Technical Service Bulletin

MODEL(S)
AFFECTED: **M17**

SUBJECT: Vacuum fan(s) turning off after a few minutes of operation. Error code 520 (static discharge interfering with vacuum fan operation) appears in the display when the vacuum fan(s) stop operating.

PURPOSE: Update machines to eliminate problems causing error code 520 to occur.

FIG. 3 - Harness, Ele [Static Gnd, M17] / Plate, Fan, Guard

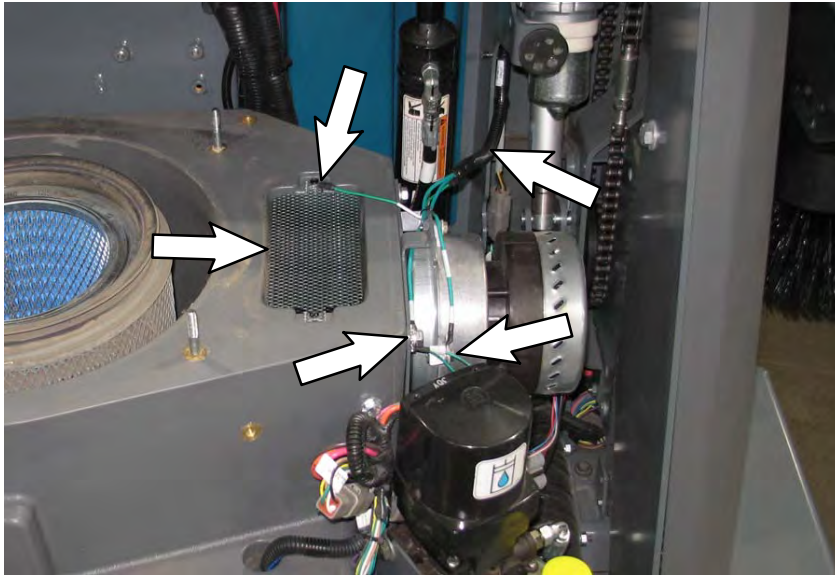
1. Check sweep board revision number. The sweep board should be labeled revision 01. Machines above serial number M17- U00061 already have this circuit board installed. Replace sweep board if it is labeled revision 00 (machines serial numbers below M17- U00061). (Fig. 1 / Fig. 2)
If a new Sweep Board is required, order Circuit Board Kit, Swp, Side, Afmkt [M17] - Kit Number 9015048. The IB for this kit is IB 9015110.
2. Use Service Diagnostic Tool to check software revision. If necessary, update to latest software revision.
3. Check if vacuum fan static harness / fan guard are installed. Machines above serial number M17- U00063 already have the vacuum fan static harness / fan guard installed. Install vacuum fan static harness kit onto machines serial numbers below M17- U00063. (Fig. 3)

Note: Machines serial numbers M17- U00019 through M17- U00063 may have an incorrectly installed static harness. If this harness is installed, and is not connected directly to a thread roller in the frame (connected to the hopper down switch bracket instead), it should be replaced.

If a vacuum fan static harness / fan guard are required, order Harness Kit, Vac Fan, Afmkt [Static Ground] - Kit Number 9015386. The IB for this kit is IB ~~9015386~~ **9015268**
